# UNITED STATES PATENT AND TRADEMARK OFFICE

APPLICATION NO.	FILING DATE	FIRST NAMED INVENTOR	ATTORNEY DOCKET NO.	CONFIRMATION NO.
09/737,770	12/18/2000	In-Duk Song	8733.339.00	8950
30827	7590	03/05/2010		
MCKENNA LONG & ALDRIDGE LLP 1900 K STREET, NW WASHINGTON, DC 20006			EXAMINER	
			RUDE, TIMOTHY L	
			ART UNIT	PAPER NUMBER
			2871	
			MAIL DATE	DELIVERY MODE
			03/05/2010	PAPER

<b>Office Action Summary</b>	<b>Application No.</b> 09/737,770	<b>Applicant(s)</b> SONG, IN-DUK
	<b>Examiner</b> TIMOTHY RUDE	<b>Art Unit</b> 2871

**DETAILED ACTION**

**FIG.2E**

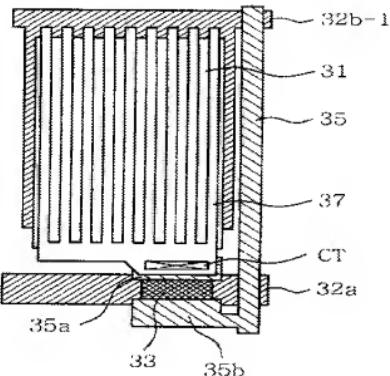
Jeon teaches 1) in Figures 2A-2E, an in-plane switching LCD device comprising: a gate line, 32a, on a first substrate; a data line, 35, on the first substrate, the data line being perpendicular (as illustrated) to the gate line; a common line, 32b-1, on the first substrate, the common line being parallel (as illustrated) with the gate line and being formed of a metal (Applicant's first material, Cr for both gate line and common line; col. 2, lines 49-58, especially lines 55-58) (Applicant's wherein the common electrode is formed on the substrate like the gate line); a pixel electrode, 37, (ITO; col. 3, lines 18-22) and the common electrode, 31, (ITO; col. 2, lines 64-67) being formed of a transparent conductive material (ITO, Applicant's second material different from the first

material); and a liquid crystal layer between the first and second substrates (inherent to comprising a LCD device) made by a method that simplifies the process by reducing the mask number [considered to meet Applicant's newly added limitations in so far as possible per Figure 13].

Jeon is evidence that ordinary workers in the art of liquid crystals would find the reason, suggestion, or motivation to modify the LCD design to permit manufacture by the method of Jeon to simplify the process by reducing the mask number.

Therefore, it would have been obvious to one having ordinary skill in the art of liquid crystals at the time the invention was made to modify the LCD of APA with the specific layered structure of Jeon to permit manufacture by the simplified process of Jeon to reducing the mask number.

FIG. 1

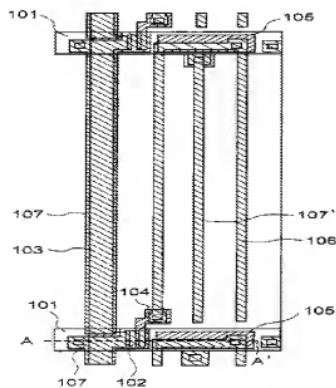
Ando teaches 2) [col. 6, line 29 through col. 8, line 46] a storage capacitor, 105 (Applicants storage electrode), over the common line, 101, and between the pixel electrode and the first substrate, wherein the storage capacitor contacts the second

connecting line, 106, via a contact hole per Figures 1 and 2 in order to comprise his invention for an in-plane switched LCD with improved aperture ratio [abstract].

Ando is evidence that workers of ordinary skill in the art would find the reason, suggestion, or motivation to add to an in plane switched LCD a storage capacitor over the common line, wherein the storage capacitor contacts the second connecting line via a contact hole to comprise a display with improved aperture ratio.

Therefore, it would have been obvious to one having ordinary skill in the art at the time the invention was made to modify the invention of APA in view of Jeon and Wakagi with the storage capacitor over the common line, wherein the storage capacitor contacts the second connecting line via a contact hole of Ando to comprise a display with improved aperture ratio.

FIG. 3

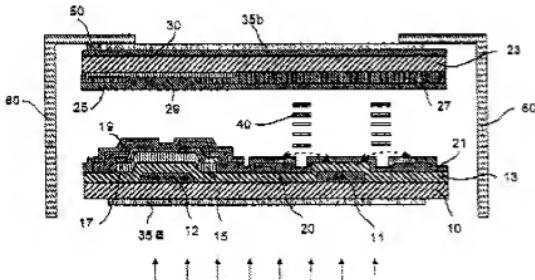
Son teaches in Figure 3, an LCD device, further comprising a light-shielding layer, 25, (Applicant's black matrix) on the second substrate, 23, (para 0029).

Son is evidence that ordinary workers in the art of liquid crystals would find the reason, suggestion, or motivation to use a black matrix on the second substrate to prevent light from leaking around the TFT (first two lines of para 0029).

Therefore, it would have been obvious to one having ordinary skill in the art of liquid crystals at the time the invention was made to modify the LCD of APA in view of Jeon, Wakagi, and Ando with the black matrix on the second substrate of Son.
